SERVICE ADVISORY # 25-460

Coleman Water Heater Switch

Models Included: 2025 Coleman 13B Travel Trailer

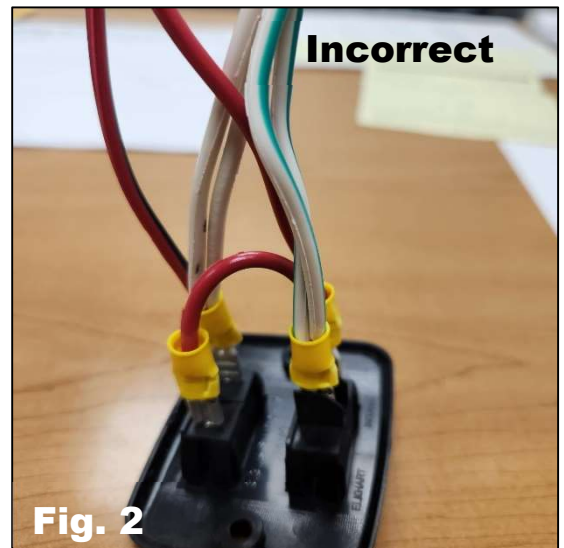
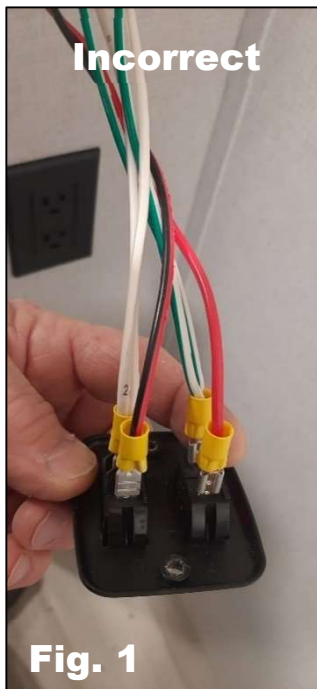
It has been determined that the water heater switch may be wired incorrectly. The following procedure describes how to identify and repair water heater wiring.

The remedy is to repair wiring at the switch. Red wire to top of switch and Green/White wires on bottom of the switch.

Remove water heater switch and inspect the wiring, see Figures 1 and 2. If the wiring is incorrect, proceed to Step 4 to repair wiring.

**Fig. 3****Step 4**

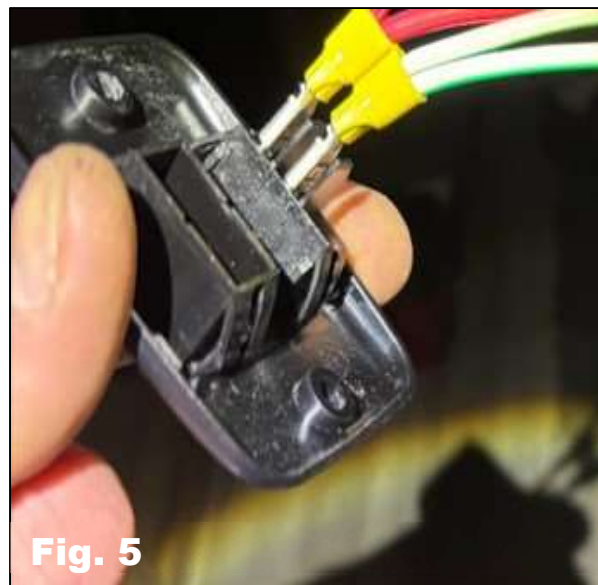
If wiring is correct, proceed to warranty reimbursement. If the wiring is incorrect proceed to Step 4 to repair wiring. Figure 3 shows wired correctly using bell cap to protect wires.

To repair wiring, ensure red wire is on the top post of the switch. If a red jumper is present, cap it off with a bell cap. Both green/white wires go together on the bottom of the switch. Red/black wire and the two white wires should be capped together as shown in Fig 3. Discard red light and install switch blank. Proceed with warranty reimbursement.
